FORM-BASED ZONING REPORT

►	FILE #: 4-A-26-OB	AGENDA ITEM #: 44
	POSTPONEMENT(S): 4/9/2026, 5/14/2026	AGENDA DATE: 8/13/2026
►	APPLICANT: RYAN ROBERTSON	
	OWNER(S): Doyle E Arp Kerbela Temple Holding Corp.

TO: City of Knoxville Administrative Review Committee
FROM: Knoxville-Knox County Planning
DATE: July 17, 2026
PLANNING FILE #: 4-A-26-OB
SUBJECT: 315 Kerbela Ave. – Level III Alternative Compliance Review

TO: City of Knoxville Administrative Review Committee
FROM: Knoxville-Knox County Planning Commission
DATE: May 20, 2026
PLANNING FILE #: 4-A-26-OB
SUBJECT: 315 Kerbela Ave. – Level III Alternative Compliance Review

315 Kerbela Ave, Knoxville, TN
May 26, 2026
Page: 34

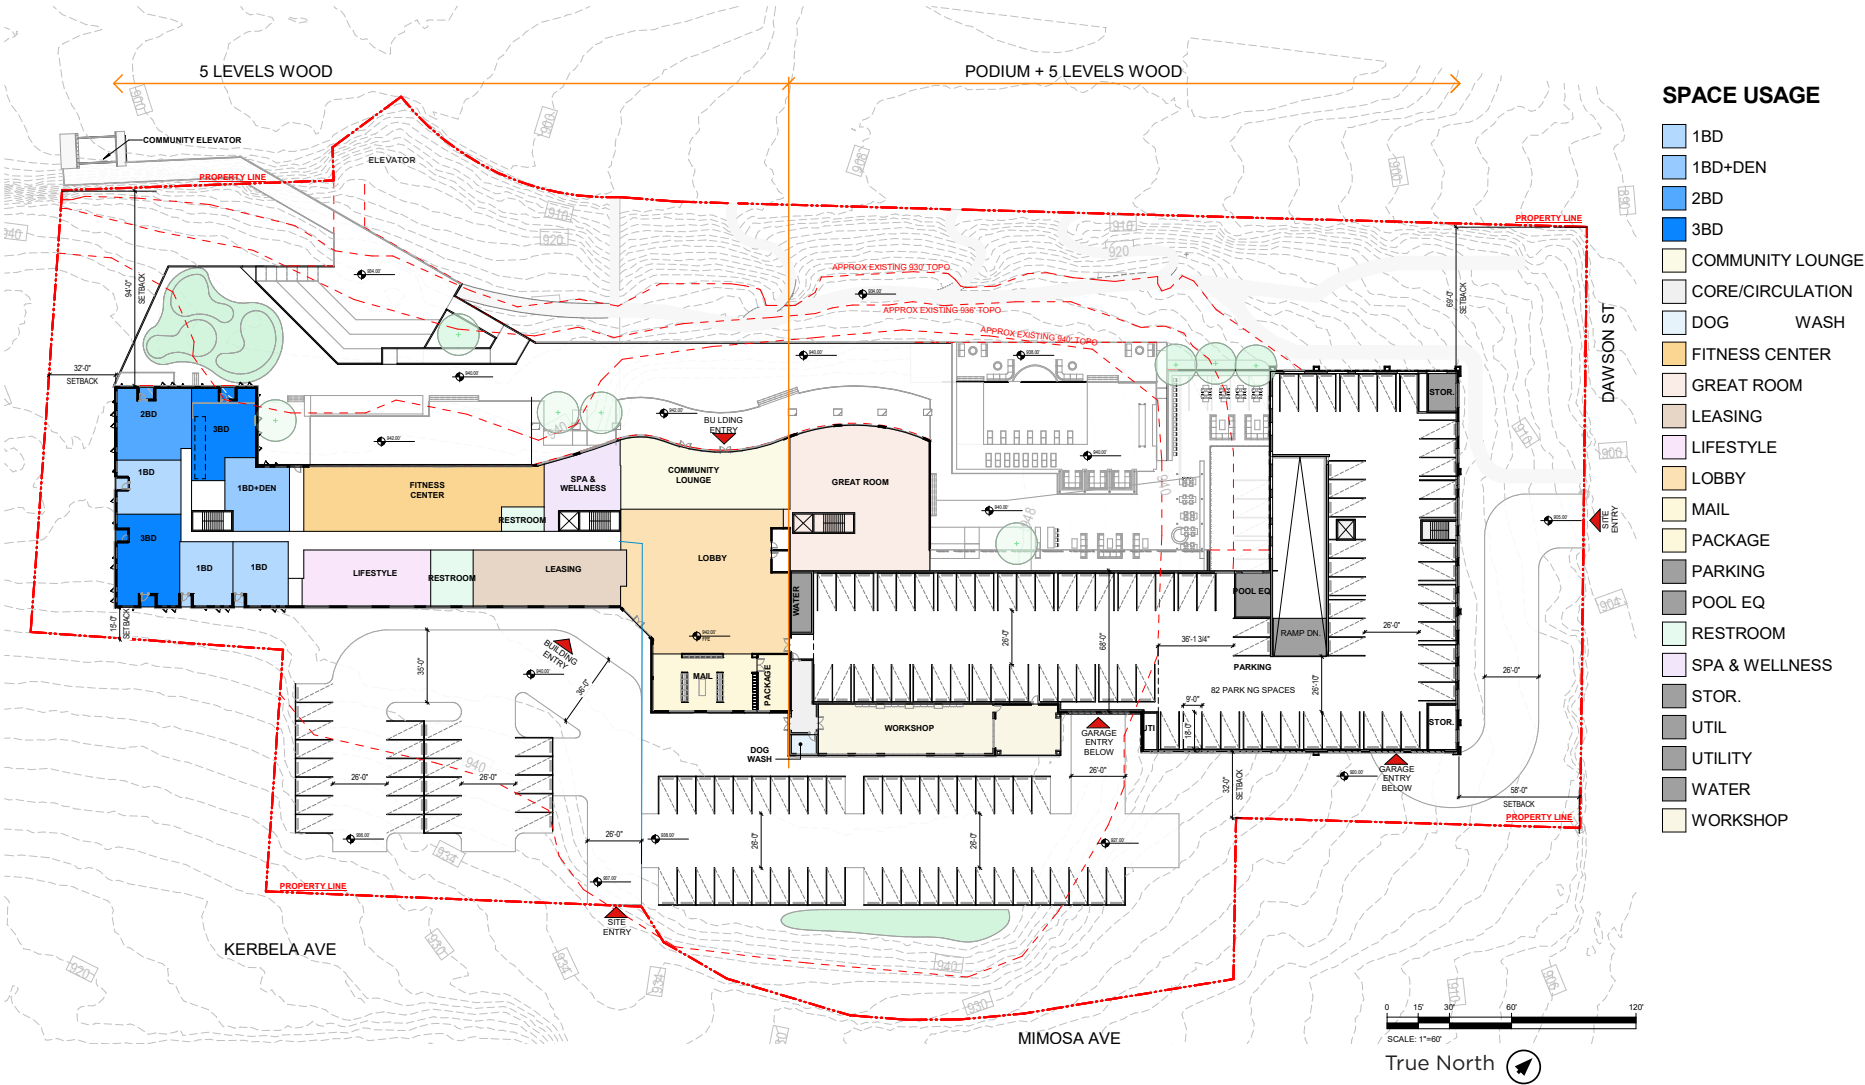
1. Extension of the east-west pedestrian pathway approximately 75 ft from the western "ghost stair" to a newly proposed public plaza comprising 1,400 sqft within a public use area of 2,400 sqft. The measurements are based on the information presented in the revised site plan. [Rendered Site Plan (New Design), page 34 of the plan set (revised 5/27/2026)]

2. Installation of approximately 155 ft of sidewalk and other streetscape improvements along Mimosa Avenue that would not otherwise be required per Article 7.1.5, Streetscape Standards, of the South Waterfront Form Code (SW code). [Rendered Site Plan (New Design), page 34 of the plan set (revised 5/27/2026)]

3. Lighting the existing rock pile and providing an art installation to activate the Sevier Avenue and Dawson Street corner of the property. [Rendered Site Plan (New Design), page 34 of the plan set (revised 5/27/2026), and the corner activation narrative in Exhibit D, applicant's response document]

4. Lighting the ghost stairs. [Rendered Site Plan (New Design), page 34 of the plan set (revised 5/27/2026), and Exhibit D, applicant's response document]

North Elevation

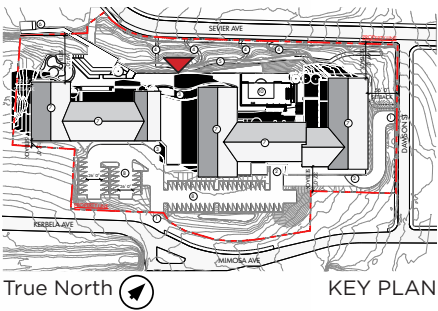
The provided elevations show a ground floor glazing calculation of 71%; however, there is a note that suggests that the ground floor area of the garage was excluded from the calculations. The ground floor area of the garage shall be included in the calculations, and the complete ground floor transparency calculation is unable to be determined on your elevation plan. Our updated ground floor glazing elevation reaches 63% due to the slope perpendicular to Dawson Street exceeding 22%.

- Article 7.1.3.F.6 & 7.1.3.G.6– Building Entries – Ground Level - Min 70% transparent glass at the ground level on the principal frontage. The provided elevations show a ground floor glazing calculation of 71%; however, there is a note that suggests that the

ground floor area of the garage was excluded from the calculations. The ground floor area of the garage shall be included in the calculations and the complete ground floor transparency calculation is unable to be determined on your elevation plan. Please provide a transparency calculation that includes the garage ground floor area. If the calculation is less than 60%, it will need approval as a Level III: Alternative Compliance Review.
